REMARKS

Serial Number: 10/823,666  
OA dated 3/31/05  
Amdt. dated 6/30/05

10/823,666  
ANNOTATED MARKED-UP DRAWING

FIG. 1

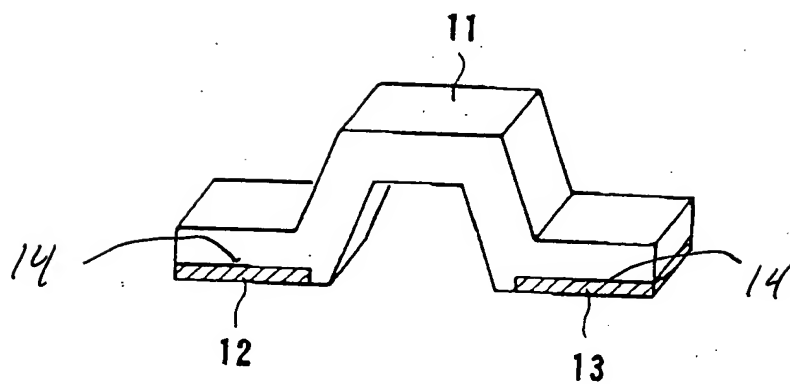
In the Office Action, the drawings were objected to as not showing all of the features being claimed. Specifically, it was alleged that the drawings fail to show the "grooves" as recited in claims 14 and 15.

Figure 1 has been amended to include the numeral 14 to identify grooves. An annotated marked-up drawing as well as a Replacement Sheet are attached herewith.

In response, Figure 1 of the drawings has been amended to include the numeral 14 for the two grooves. Additionally, lines 15-17 of page six of the specification have been amended to read as follows:

"In the case of the inlay cladding structure, it is necessary to pre-fabricate grooves 14 in the base material for inlaying the metal strips 12 and 13."
